2022 Design Competition Frequently Asked Questions

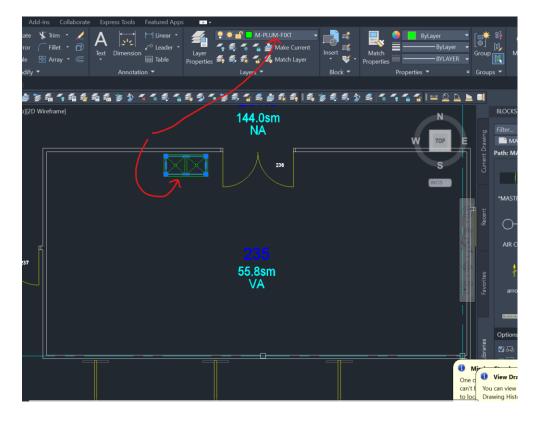
Q: There are a few areas where the ceiling grid is unclear on the CAD drawings. I've checked the layers and the ceiling grid is turned on. I've attached a picture of one of the areas in question. Should we assume this entire area has a dropped ceiling?

A: Teams should just assume it is a drop ceiling everywhere.
